SCHWEIZER SERVICE BULLETIN

DB-018.3*
13 Dec 2007

SUBJECT: INSPECTION FOR FATIGUE CRACKING IN 269D3300-1 AFT FUSELAGE ASSEMBLIES AND INSTALLATION OF STABILIZER MOUNT DOUBLERS

MODELS AFFECTED: All Model 269D and 269D configuration "A" Helicopters Serial Numbers 0001 through 0062A that are equipped with 269D3300-1 Aft Fuselage Assemblies.

Figure DB-018-1

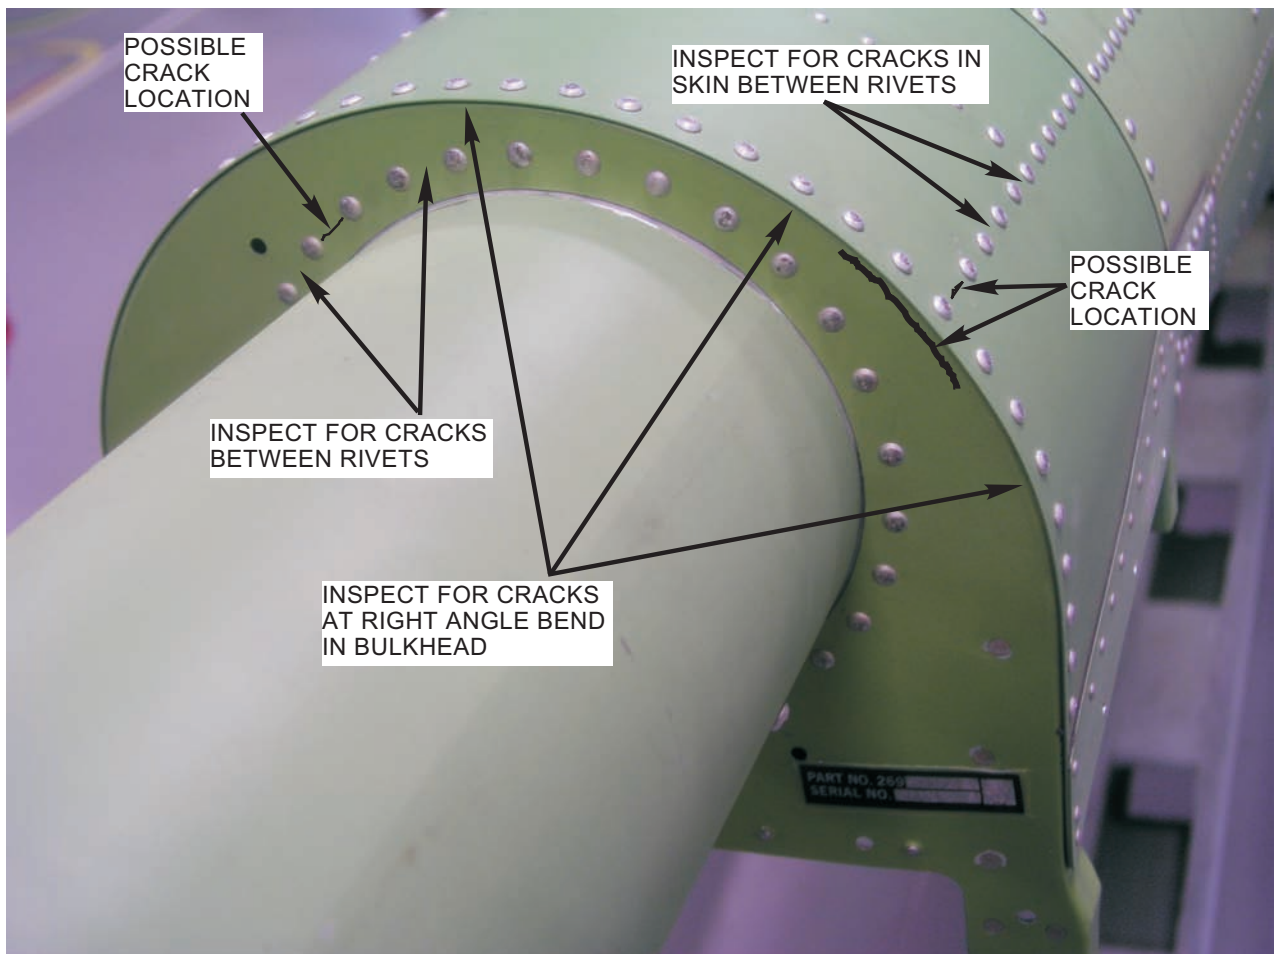
- a. Visually check aft bulkhead and adjacent skin for cracks and cracks in paint film in the areas indicated in Figure DB-018-1. If cracks in metal structure or in paint film alone are found, or new cracks extend from under repair patches, perform an interior inspection in accordance with Part II of this Service Bulletin before next flight.

NOTE: VISUALLY INSPECT SKIN AND BULKHEAD, WITH PARTICULAR EMPHASIS ON AREAS INDICATED BY ARROWS.

- c. Using a bright light and mirror or borescope, inspect interior structure for cracks in longerons, bulkheads, tailboom tube attachment collars (split rings around tube attaching tube to bulkhead), brackets, and clip (between right side longeron and tailboom tube). Assure all sides of tailboom tube are thoroughly inspected and pay particular attention to rivet lines and bend radius in components. If cracks are found in the aft fuselage assembly, they must be repaired before next flight.
- d. Damaged longerons, tailboom tube collars, or a damaged forward stabilizer bulkhead, require that the aft fuselage be returned to the factory for repairs. Contact Schweizer Aircraft Customer Support Department for details.

- e. Aft fuselage assemblies with a cracked clip, cracks in aft bulkhead and/or adjacent skins (Fig. DB-018-1), can be repaired locally in accordance with Basic HMI Section 11. 269D3300-1 assemblies that have been repaired, require a periodic inspection of the interior structure at each 200 hours of operation after repair.

Figure DB-018-2

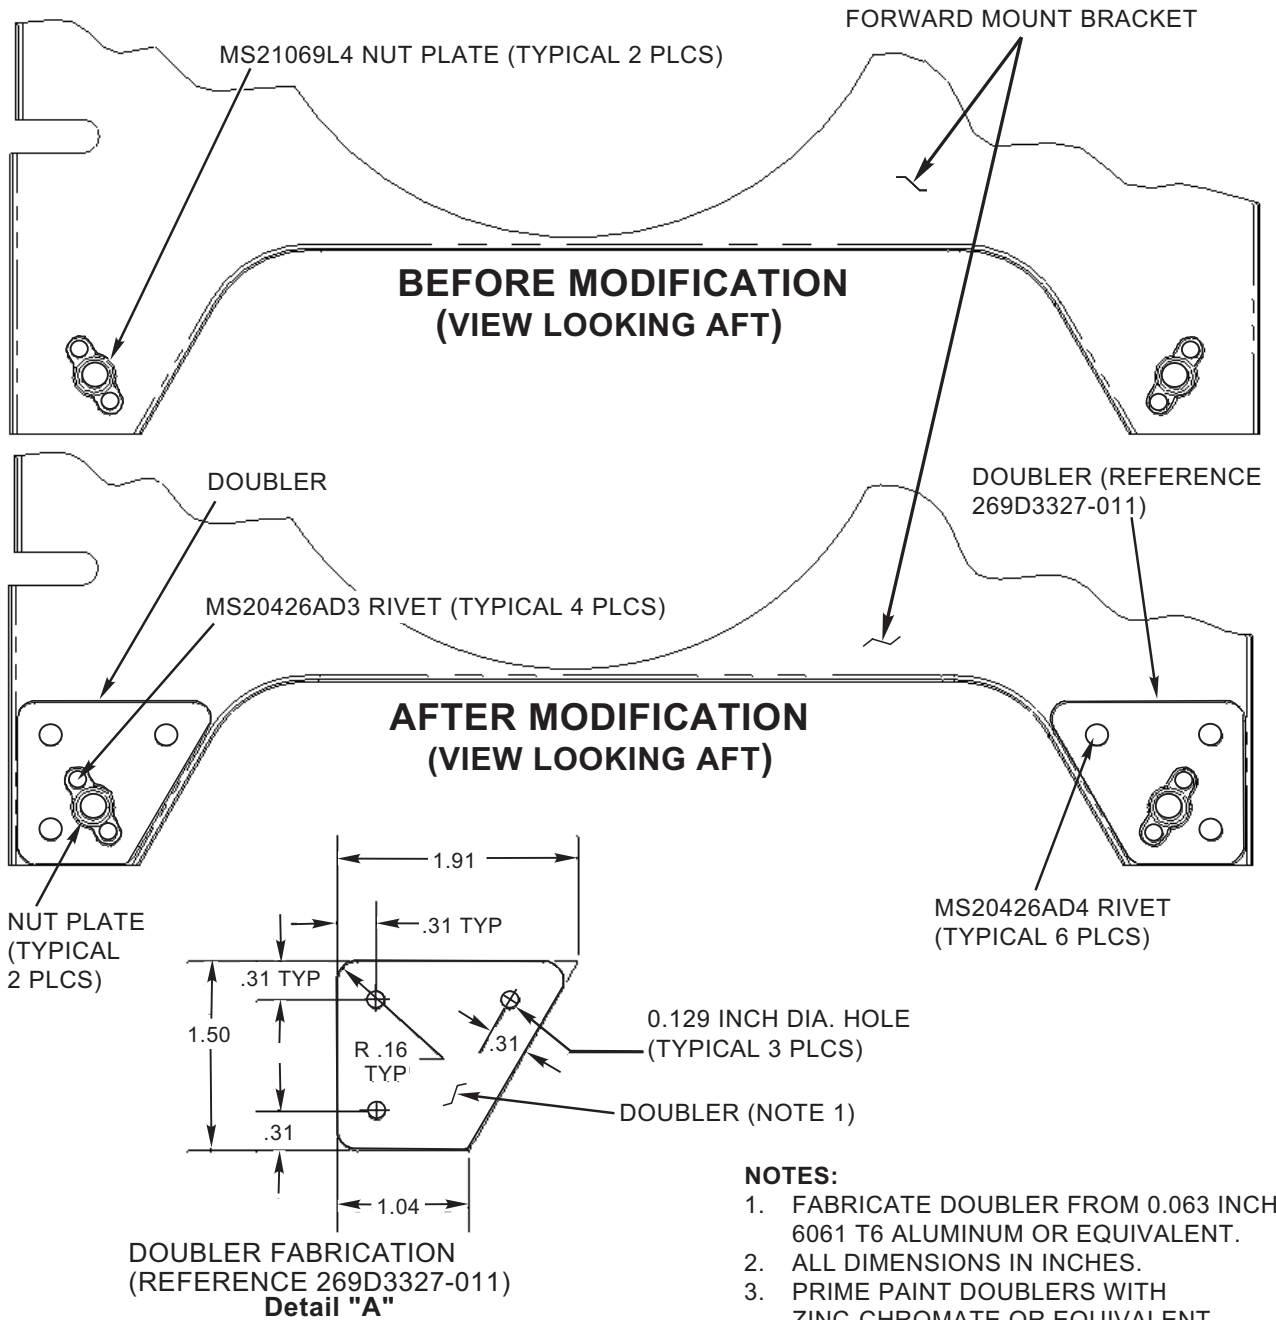
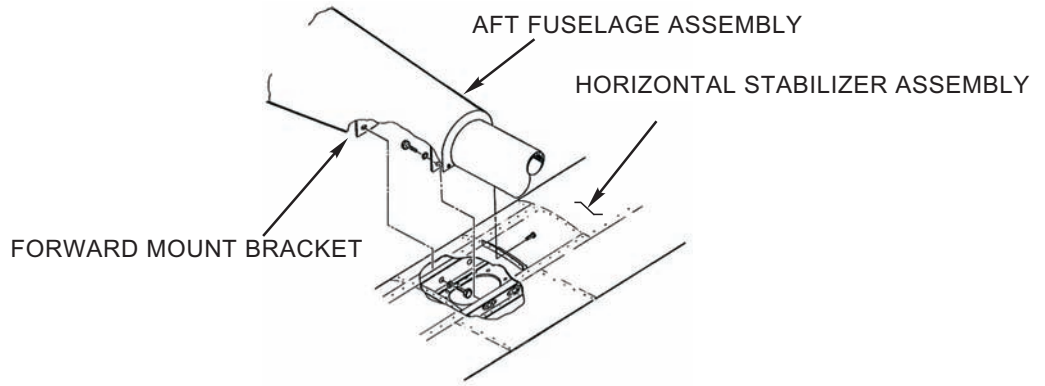
- e. Place 269D3327-011 doublers in position on forward side of mount brackets as shown in Figure DB-018-2 and trim doublers as required to provide a flush fit against bracket face. Clamp doublers securely in place after trimming.

- f. As shown in "Detail A", locate positions of six MS20426AD4 rivets and drill 0.129 inch rivet holes through brackets and doublers using a #30 drill.

- g. Using existing bolt holes and nut plate rivet holes in frame as guide, carefully drill 0.096 inch nut plate attachment rivet holes using a #41 drill and 0.250 – 0.252 inch bolt holes using a ¼ inch drill through doublers. Note position and orientation of doubler installations and remove doublers and de-burr holes.

- h. Using a dimple tool, dimple six 0.129 inch rivet holes in mount bracket from aft side (rivets to be installed flush on aft side of bulkhead). Using a 100° countersink, countersink six rivet holes in doublers to match rivet hole dimples in brackets. Only remove sufficient material that allows doublers to fit flush against bracket faces.

- i. Apply zinc-chromate or equivalent primer on faying surfaces between doublers and mount bracket and while primer is wet, install doublers using MS20426AD4 rivets and servicable nut plates using MS20426AD3 rivets.

After installation of the doublers on the forward support brackets, the same length NAS1304-4 bolt is now used in all four stabilizer attachment points.

1. FABRICATE DOUBLER FROM 0.063 INCH 6061 T6 ALUMINUM OR EQUIVALENT.
2. ALL DIMENSIONS IN INCHES.
3. PRIME PAINT DOUBLERS WITH ZINC-CHROMATE OR EQUIVALENT PRIMER.
